# 1964 Corvette: Engineering Service Letter: Muncie Four Speed Transmission Design Change

# ENGINEERING SERVICE LETTER

**SUBJECT:** MUNCIE FOUR SPEED TRANSMISSION - 1964 DESIGN  
CHANGE AFFECTING PAST MODELS SERVICE REPLACEMENT  
AND A FIELD FIX IF REQUIRED

**DATE** 8-20-63  
**SECTION** 7  
**MODEL** RPO M20 800-  
1200-1600-1800 & RPO  
M21-1200-1600-1800-1963

For a comparison between the new and old design in the transmission area affected see attached sketch. Old parts indicated by an asterisk (\*) are no longer required as part of revised design.

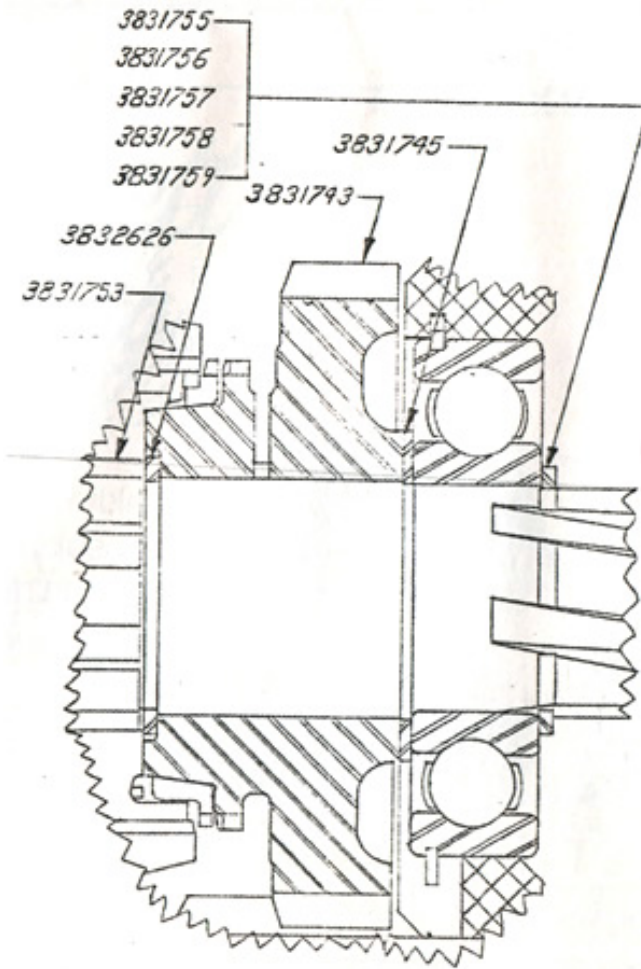
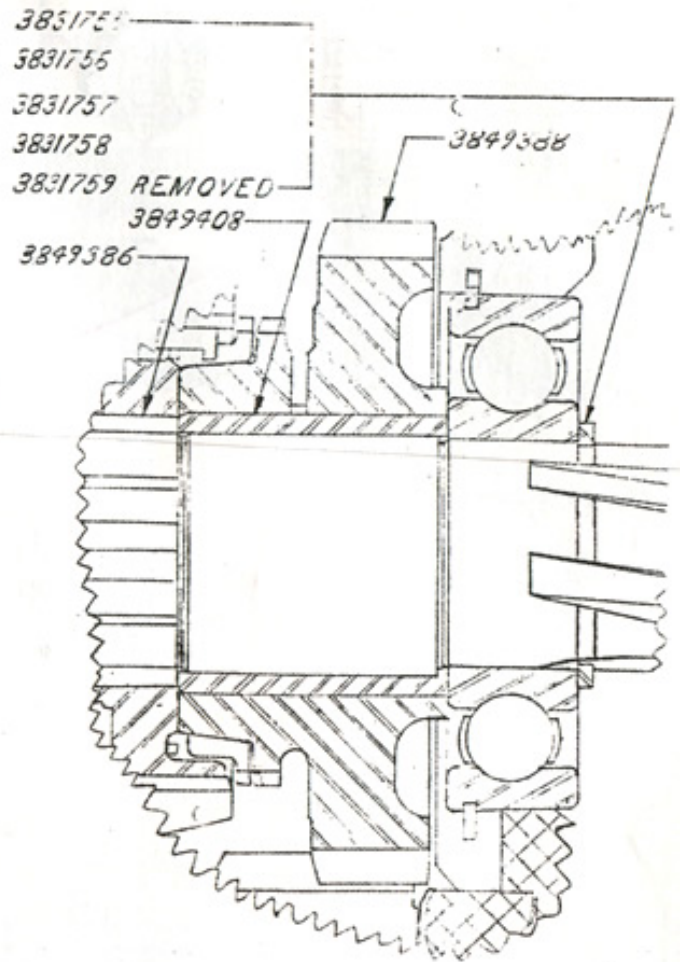
A design change is being introduced for start of production 1964 on subject transmission which includes a new transmission mainshaft, first speed gear, and first speed gear sleeve. The new parts are not interchangeable as details for service replacement on past models. The reasons for the changes are to provide positive first speed gear end clearance, and also to eliminate the possibility of seizure between the inside diameter of the first speed gear and the matching mainshaft outside diameter by use of a new sleeve. The seizure has been reported from the field in several instances at relatively low mileage, and the new parts indicated above are to be used for past model service replacement if this type of transmission failure is noted.

<u>New Parts</u>	<u>Old Parts</u>	<u>Name</u>	<u>Production Disposition</u>
3849386	3831753	Shaft - Trans. Main	Cancelled & Repl. by 3849386
3849388	3831743	Gear - First Speed	Cancelled & Repl. by 3849388
3849408	-----	Sleeve - First Speed Gear	New
-----	*3831745	Washer - 1st Speed Gear Thrust	Cancelled & Not Replaced
-----	*3831759	Ring - Trans. Main Shaft Rear Brg. Retainer	Cancelled & Not Replaced
-----	*3832626	Ring - Trans. 1st & 2nd Synchronizer Retaining	Cancelled & Not Replaced

From the viewpoint of excessive cost to the customer, if the combination of new parts was used for all past model service replacement, it was decided to maintain old stock.
